Title: Pneumatic Clutch III (2017) – Pressure Disc Inspection		
AG-SB-2018-05-B-EN		Compliance Category:
Applicability		A – MANDATORY
Aircraft type & model: All MTO2017 and all Calidus/Cavalon with rotor head III fitted	Affected Serial number(s): All MTO2017 and all Calidus/Cavalon with rotor head III fitted	B – RECOMMENDED
The maintenance manual to be referenced is this stated or subsequent issue.		C – OPTIONAL
As per AutoGyro website		
<p>This form is the response from AutoGyro GmbH either against a problem found in the product in service requiring a containment or rectification action, or as service information for aircraft modification incorporation. For help, contact AutoGyro on 49(0)5121 88056-00, or email airworthiness@auto-gyro.com.</p>

Reason and overview of the Service Bulletin (cause of problem if known)

Fig. 1 - Pressure Plate Assembly (31713)

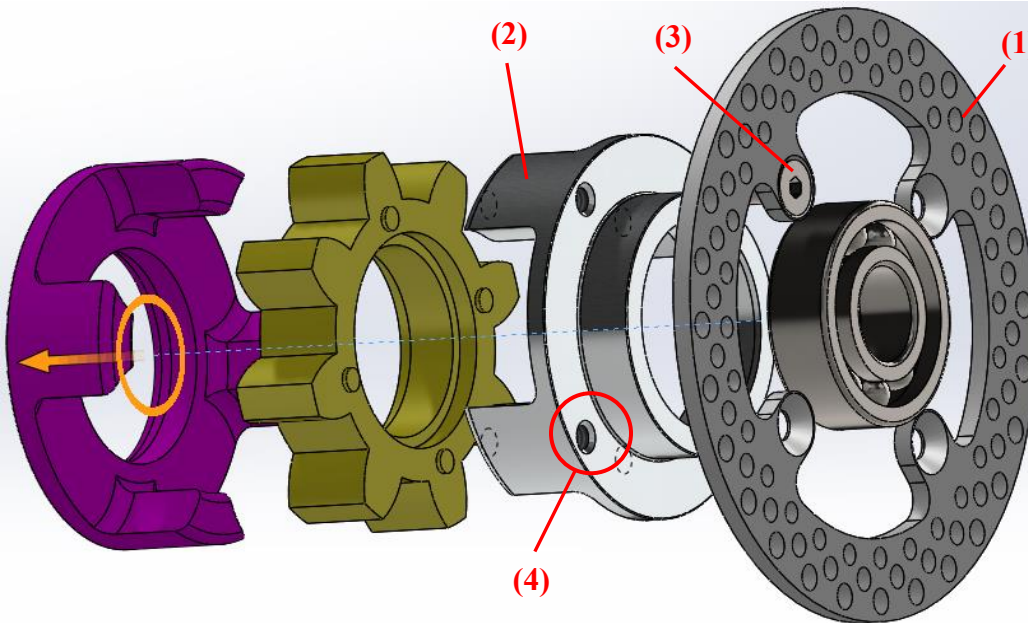
It has been found that the threaded holes in the first batch of pneumatic clutch III (2017) Pressure Plate front (2) are not sufficiently countersunk to accept the countersunk screws securing the Pressure Disc PKII (1). The effect is that the screws are unable to properly clamp the disc and plate together, possibly leading to looseness, rattle noise, and wear of this connection.

1. Remove any cowlings required to gain access to the clutch assembly.
2. Remove the pneumatic clutch from the engine in accordance with AMM job card 63-11-10 4-1.
3. Remove the center screw retaining the pressure plate assembly (31713) to the clutch in accordance with AMM job card 63-11-10 8-1 part 4.
4. Remove the pressure plate assembly (31713) from the clutch and remove the 4 countersunk screws (3) securing the pressure disc (1) to the pressure plate front (2).
5. Inspect for signs of rotational movement of the pressure disc (1) on the pressure plate front (2), and/or elongated holes in the disc (1). If damaged, replace (article 23604).
6. Inspect the complete clutch assembly for any further damage and replace any affected parts (eg. 31713 Pressure Plate Mounted).
7. Inspect the pressure plate front (2) and ensure that the threaded holes (4) are countersunk to a

- depth of 1mm with a 45° countersink. If not, re-work with a suitable countersink tool.
8. Re-assemble the clutch in reverse order of disassembly.
 9. Assemble the clutch to the engine in accordance with AMM job card 63-11-10 4-1.
 10. Re-fit any cowlings previously removed.
 11. Ground run the aircraft in a suitably secured area, including a pre-rotation clutch functional check.
 12. Note the SB action within the aircraft documentation.
